**New York State Department of Transportation
Red Flag 3B190TW049**

BIN: 3209800

Feature Carried: FREESE ROAD

Subject: Pier Footing Undermining

UNDERMINING DOCUMENTATION ALONG PIER

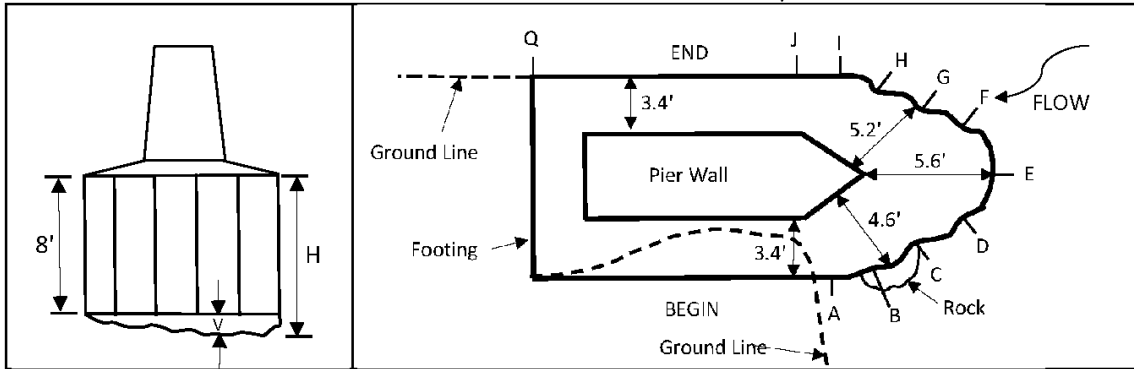
| 2019 | New undermining and Pier profile readings taken. The footing is undermined by 5 ft. + at station E. Water is 4.5 ft. +/- deep along the pier which makes accurate undermining readings very difficult. |
